"Temple Cowley CPZ amendments" - consultation response by Oxfordshire Liveable Streets and CycloX, January 2026

Junction Rd

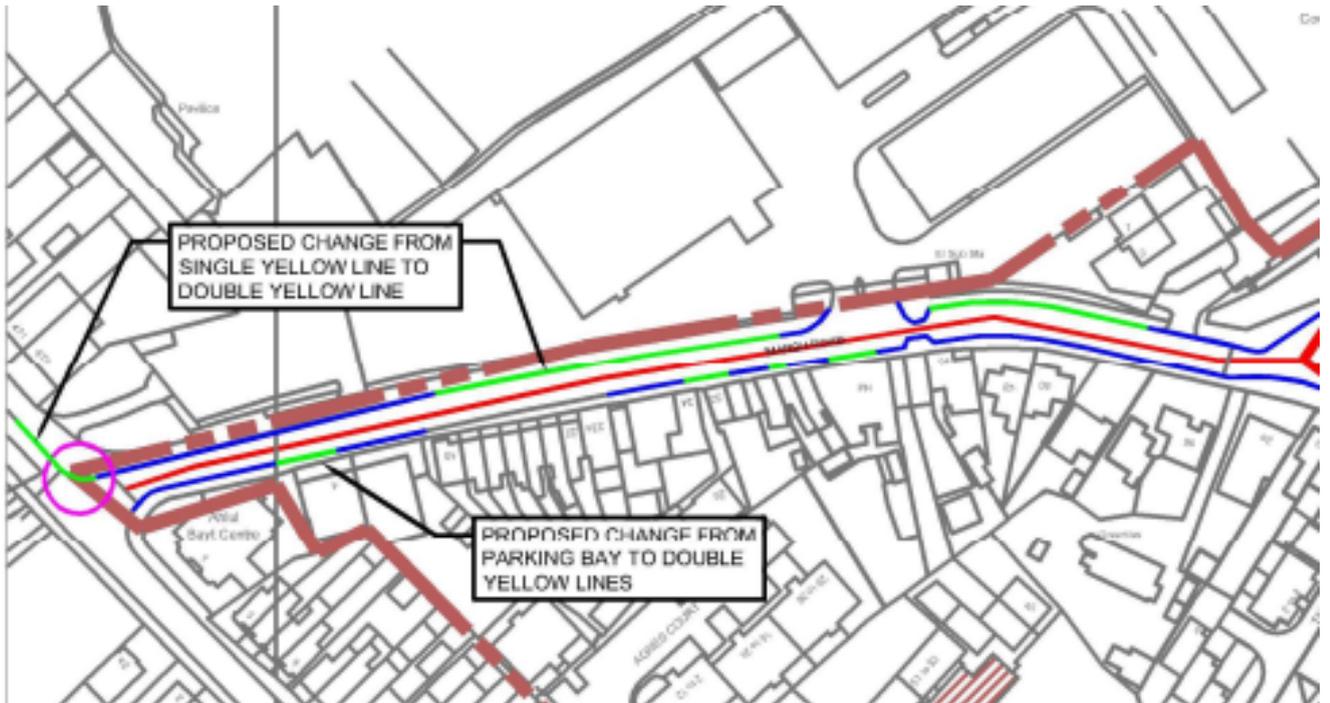
SUPPORT WITH CONCERNS

We support the provision of cycle and micromobility parking. But the scheme diagram appears to show the proposed parking bays extending onto the footway. We oppose taking footway space here and suggest that the bays can fit entirely on the carriageway.
